Conceptual Design Review of the Magnet Circuits for the HL-LHC: - 21-23 March, 2016 - **Review Report**

Reported at HL-LHC Technical Coordination Committee, 31 March, 2016

Powering and Quench protection system

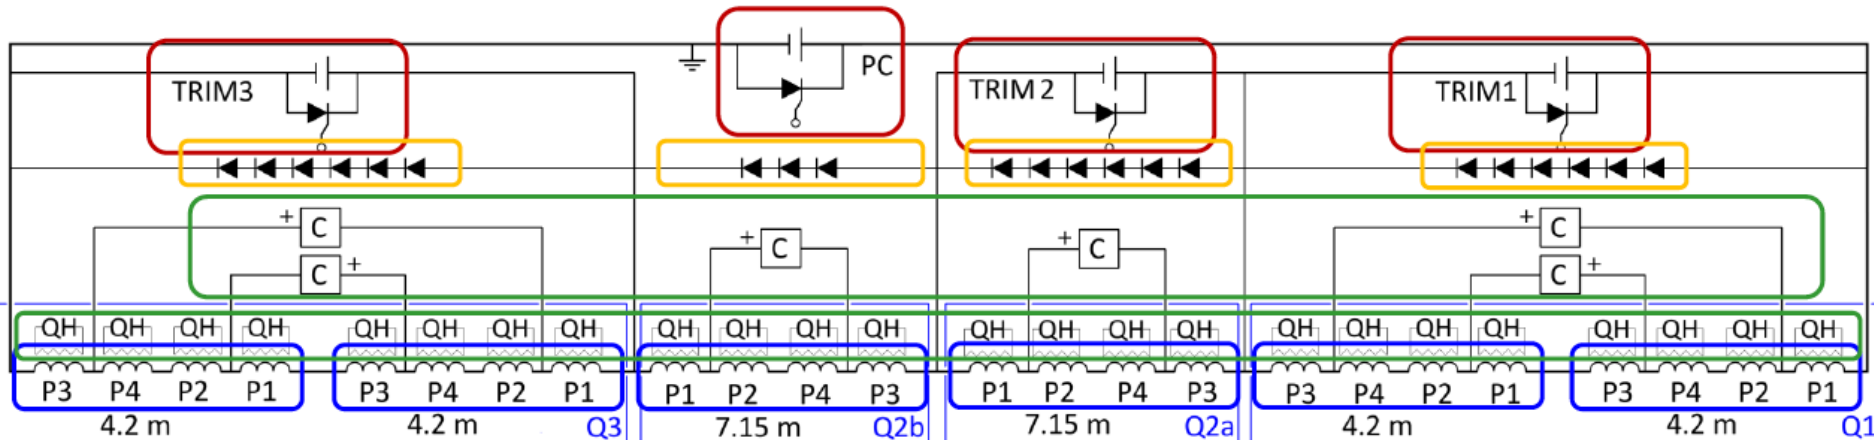
- We support the new proposal.
 - Advantages for beam dynamics (with reducing tune variation)
 - Saving CLs in main circuit
- We understand positive experience with the current inner triplet operation in series with an extra-ordinal trim scheme.

We support the new proposal !
